SEWAGE DISPOSAL TESTING

STATE OF MARYLAND - DEPARTMENT OF HEALTH AND MENTAL HYGIENE

A 31577

RE: Percolation Testing
Selene Smith Property
Tax Map 9 - Parcel 75

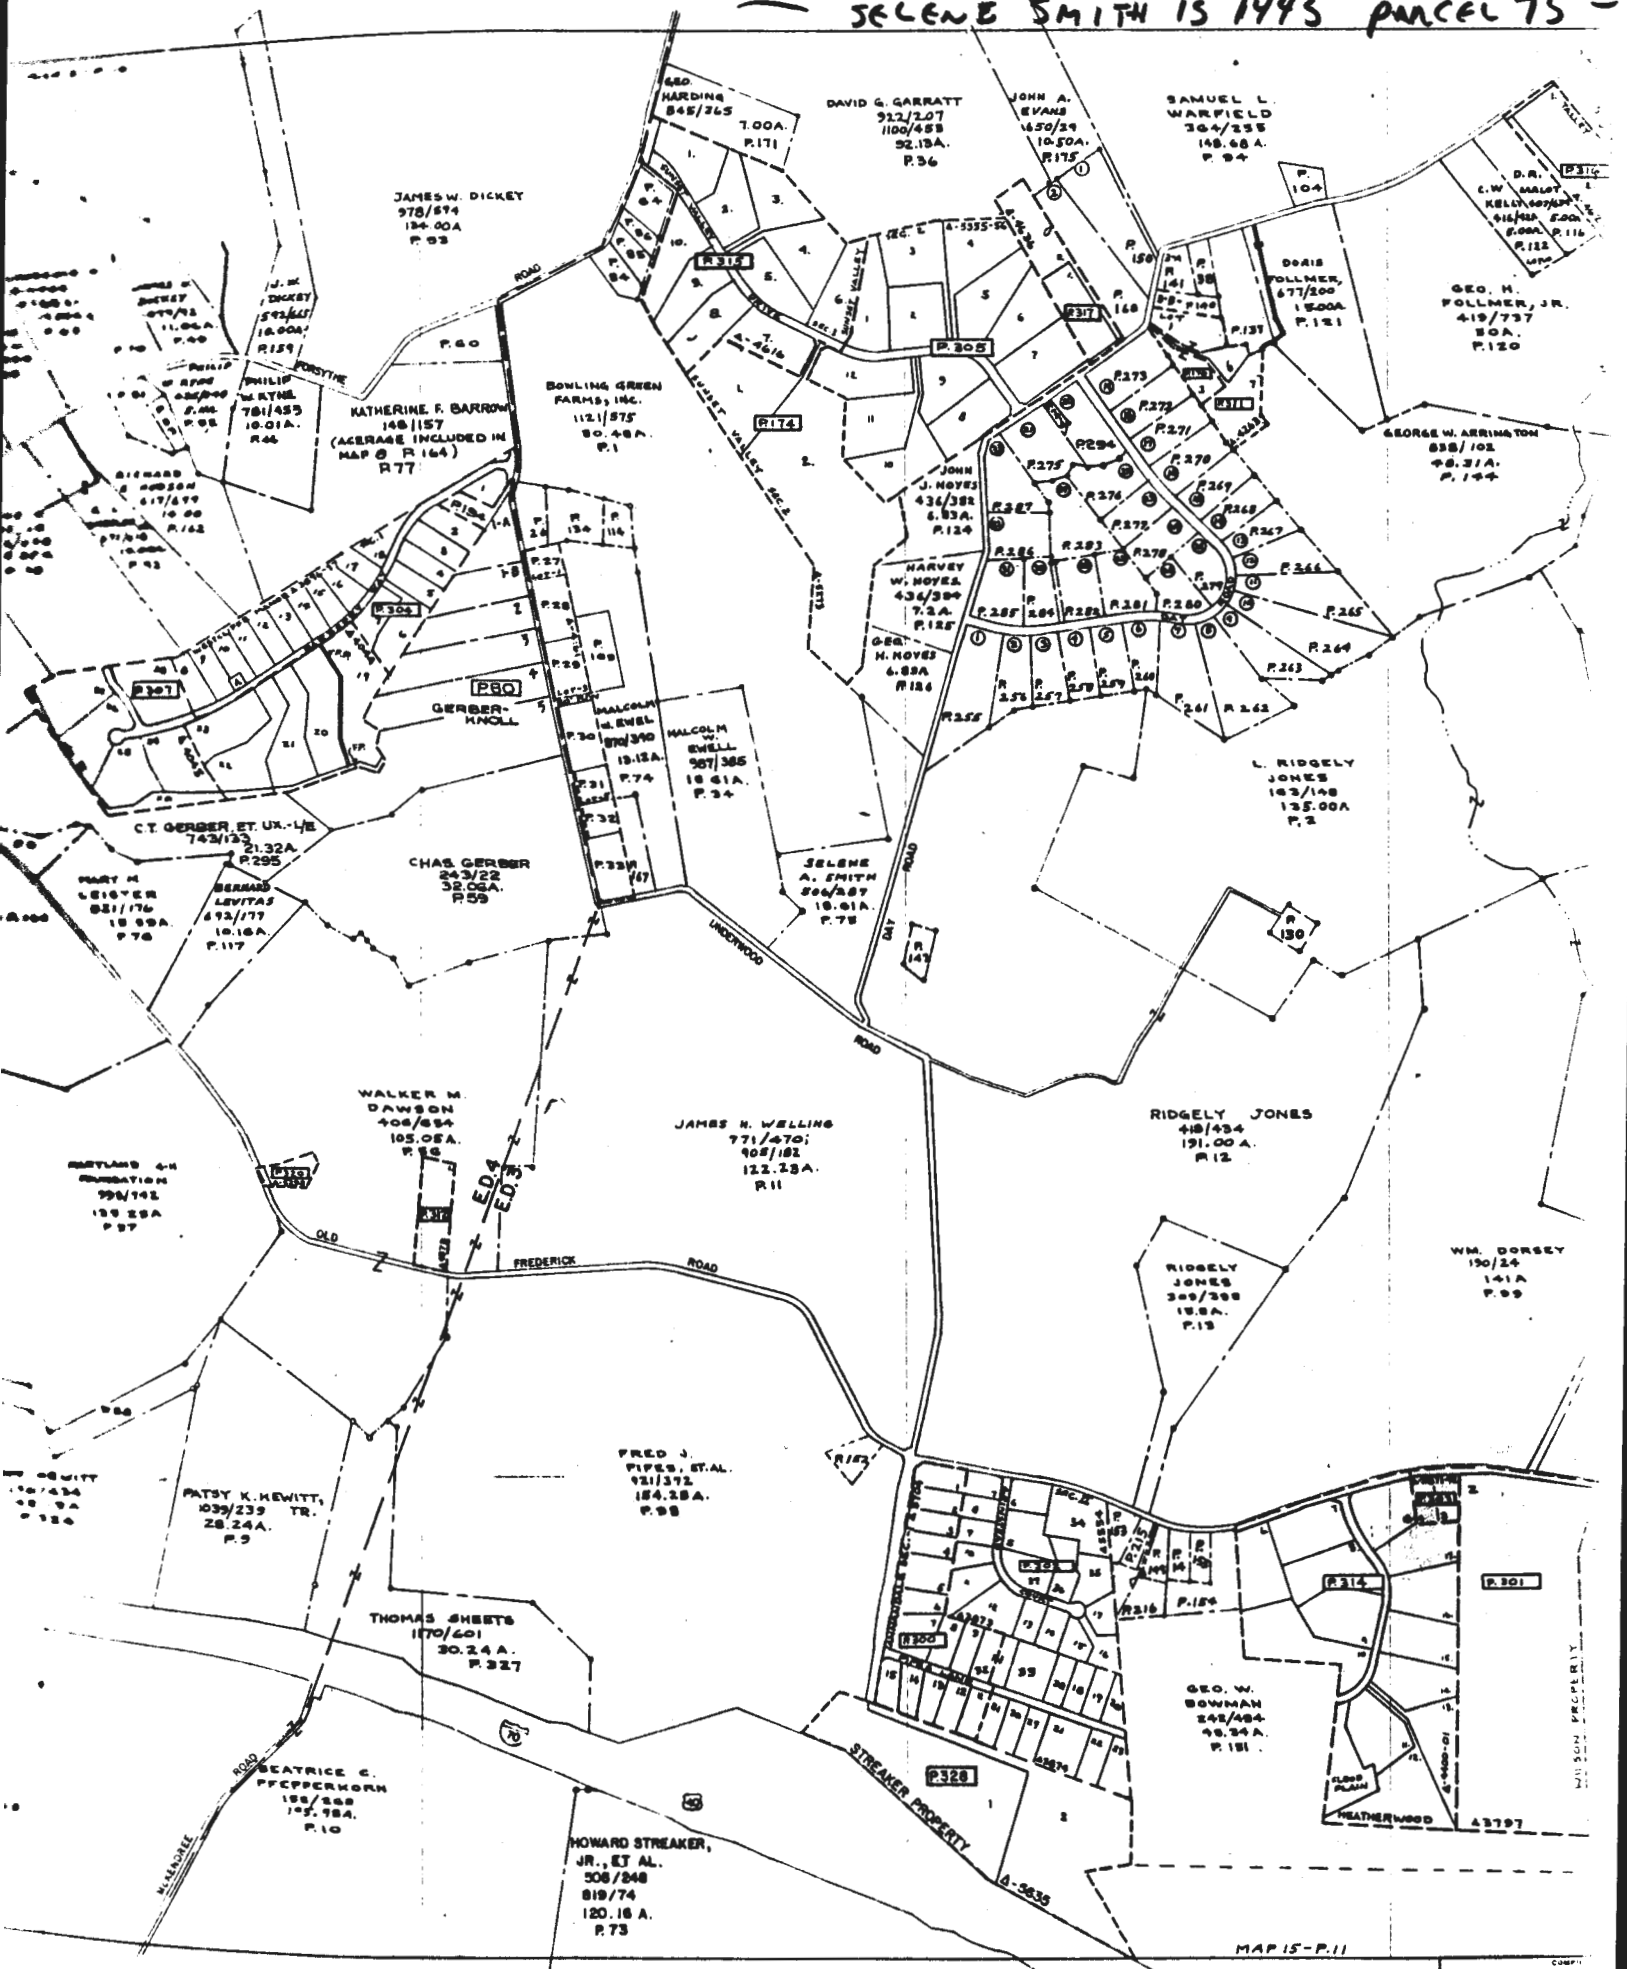
Hole 2 no good, hole #1 questionable
 see other page for comments on Lot B perc
 Red/brown clays = clay loams

H₂O level
 ↑ = 6" after
 2 hours
 3
